**Subject: MHI's Amended Responses to US-APWR DCD RAI No. 939-6334 Revision 3 (SRP 03.07.01) and No. 940-6532 Revision 3 (SRP 03.07.01)**

Amended Response to Request for Additional Information  
No. 939-6334 Revision 3

**RAI NO.:** NO. 939-6334, REVISION 3  
**SRP SECTION:** 03.07.01 – Seismic Design Parameters  
**APPLICATION SECTION:** 3.7.1  
**DATE OF RAI ISSUE:** 06/12/12

Figure 7, Response Spectra at 2% and 5% Damping – X Component (H1, North-South)

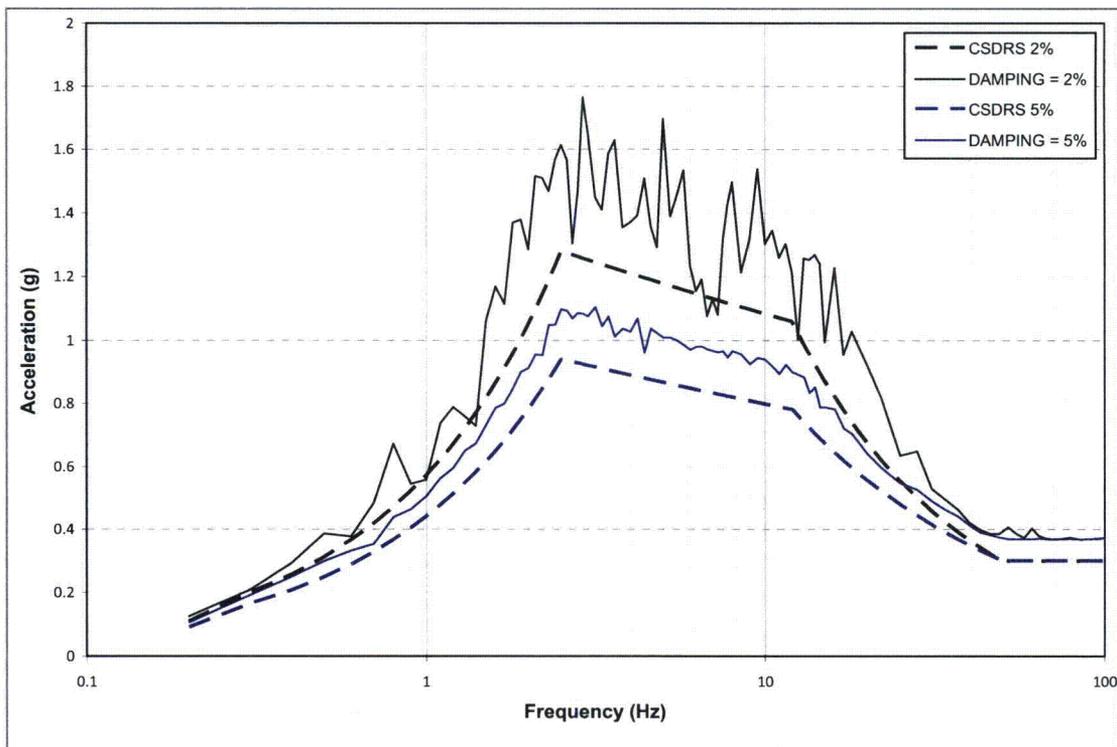
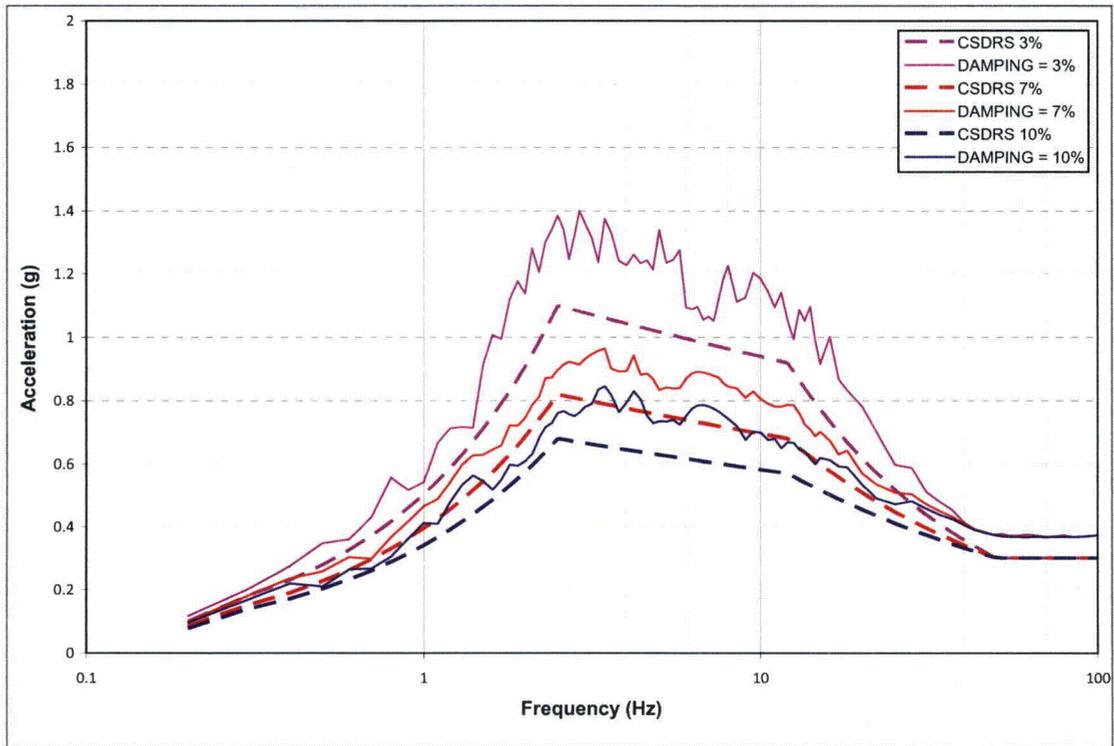
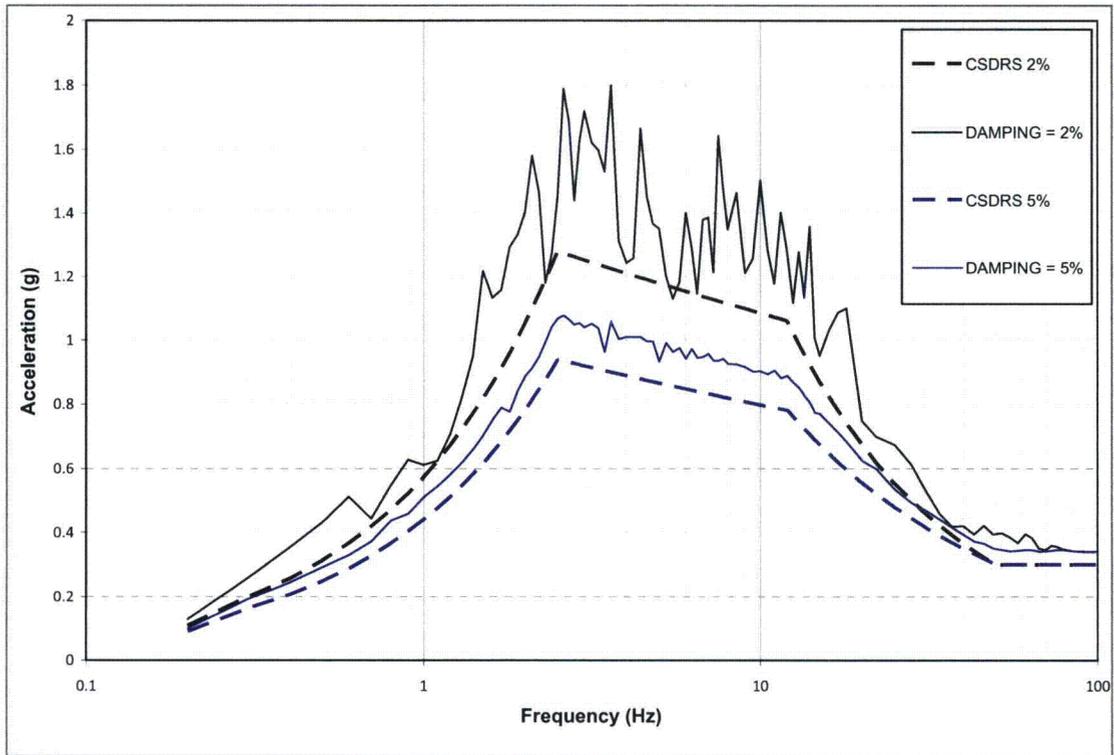
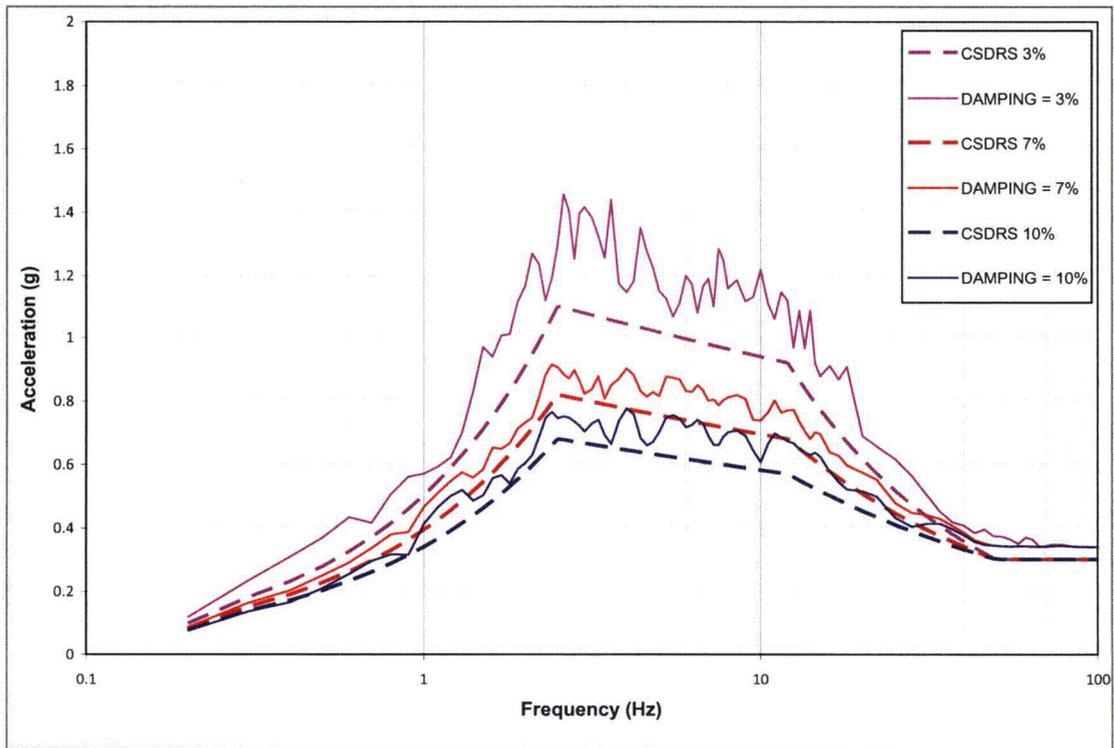
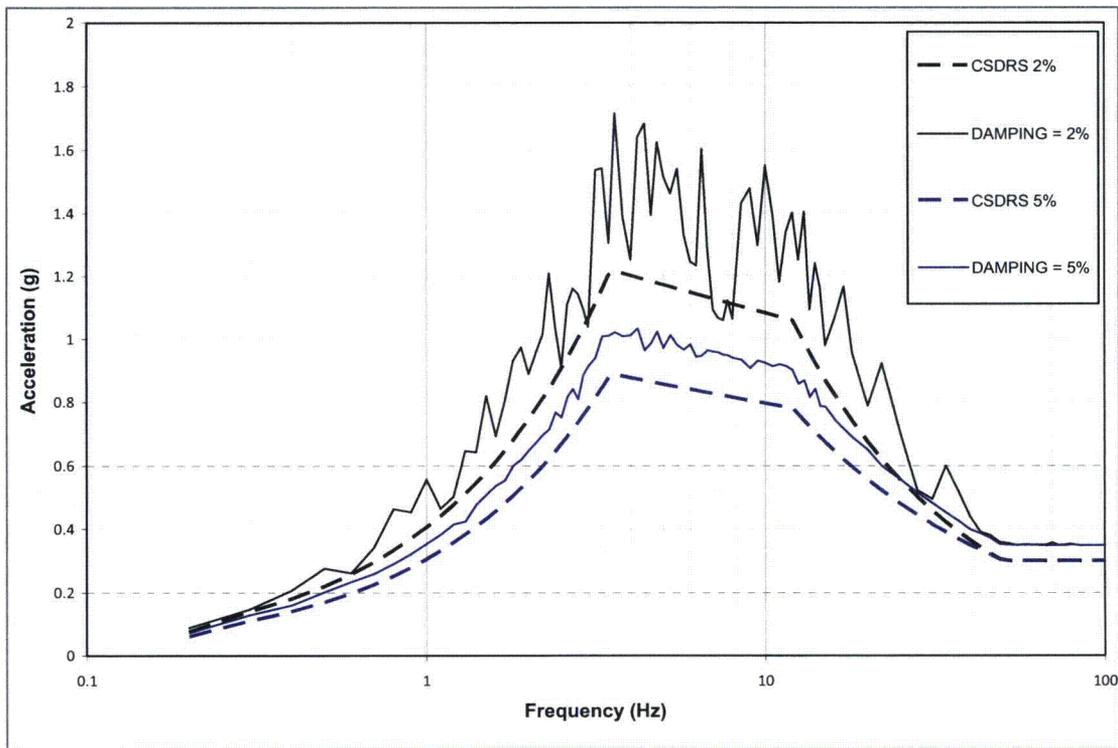
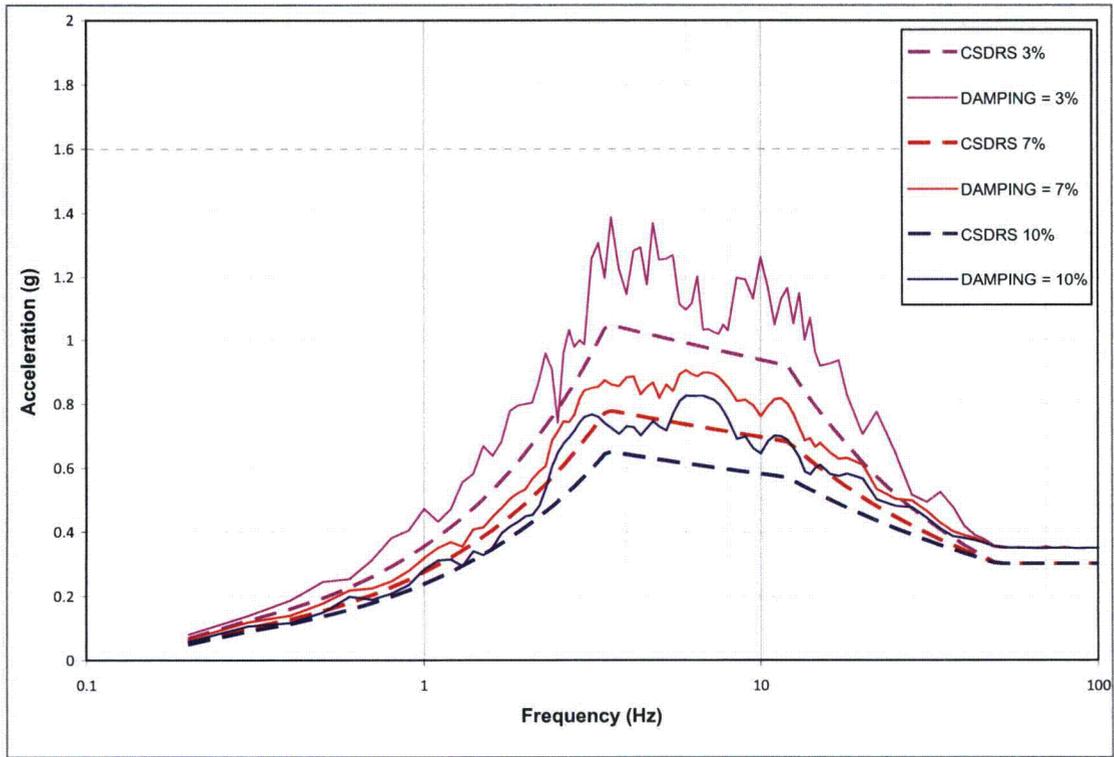
- (1) In performing the spectral matching, demonstrate that for all three directions of the CSDRS, the Option 1, Approach 1, criteria are met for 2%, 3%, 5%, 7%, and 10% damping, or justify an alternate damping range based on the values used in the design basis seismic response analysis of SSCs.
- (2) In performing the PSD match,
  - (a) develop target PSDs representative of each of the three directions the CSDRS, which are the stretched RG 1.60 spectra;
  - (b) provide the details of the method employed to develop the target PSDs; and
  - (c) describe the method and assumptions used to generate the PSDs for the synthetic time histories.

Table 1 provides numerical data that demonstrates compliance to the SRP 3.7.1 Option 1, Approach 1 criteria. It shows that the maximum number of points below the target certified seismic design response spectra (CSDRS) in each direction is equal to or less than five, which is acceptable. Further, it shows that the minimum acceleration ratio is 0.945, which meets the SRP guidance criteria of a minimum of 0.90.

The target response spectra are matched down to 0.2 Hz, which is less than the lowest frequency of interest.
